Westinghouse Electric Company
Nuclear Power Plants
P.O. Box 355
Pittsburgh, Pennsylvania 15230-0355
USA

Subject: AP1000 Responses to Requests for Additional Information (SRP3.7.2)

Responses to Requests for Additional Information on SRP Section 3.7.2

RAI Response Number: RAI-SRP3.7.2-SEB1-02
Revision: 0

Figure RAI-SRP3.7.2-SEB1-02- 1: Radwaste Building El 100'

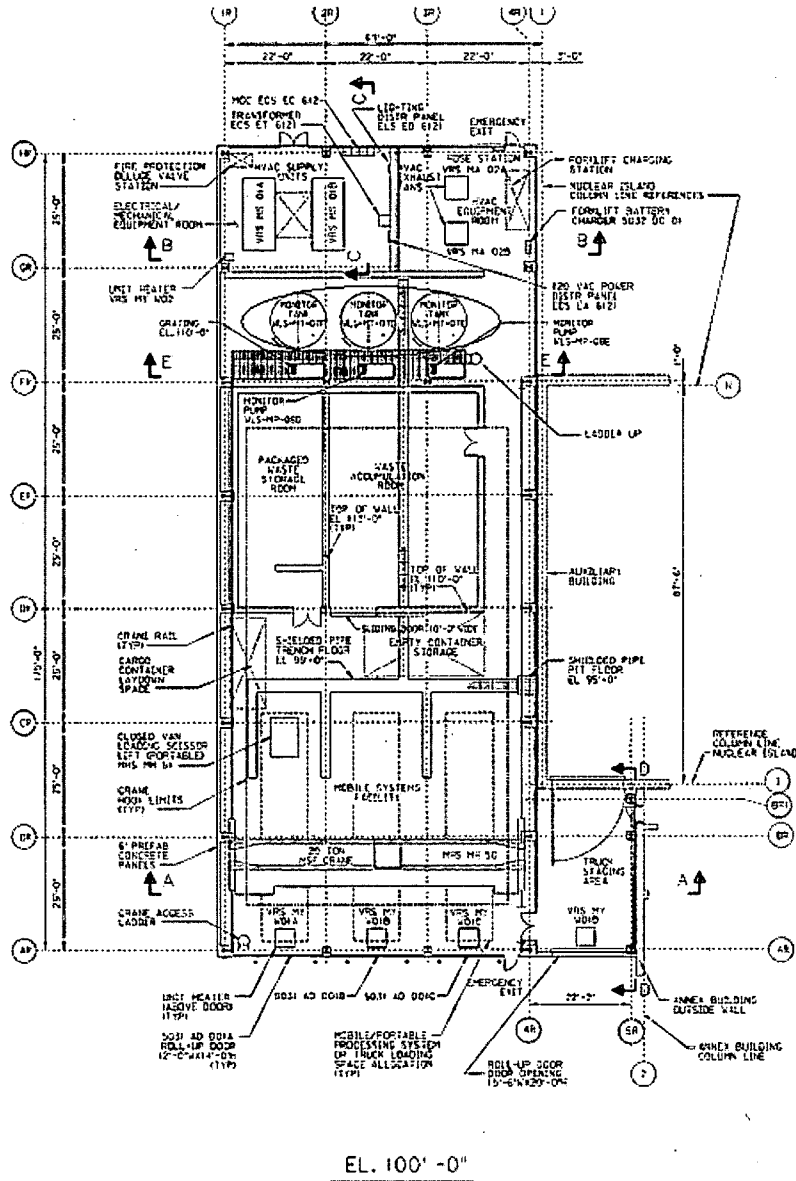
The design of the Radwaste building has been amended to incorporate three new addition liquid waste monitor tanks and the associated piping systems (see TR116). Provide a reanalysis to show that the collapse of the Radwaste building due to safe shutdown earthquake (SSE) or other extreme environmental events will not impair the structural integrity of the adjacent nuclear island (NI) structures.

The three new liquid waste monitor tanks are located in the Radwaste building between wall line FR and GR in Figure RAI-SRP3.7.2-SEB1-02- 1. As seen in this figure, the tanks are located in the area of the Radwaste building that extends beyond the Auxiliary building, which separate them from the Auxiliary building. Further, the additional three tanks are supported at the foundation level as shown in Figure RAI-SRP3.7.2-SEB1-02-2. Therefore, their mass will not participate in the potential impact of the Radwaste building onto the Auxiliary building.

It can be concluded, that the addition of three new liquid waste monitor tanks will not compromise the structural integrity of the neighboring Auxiliary building.
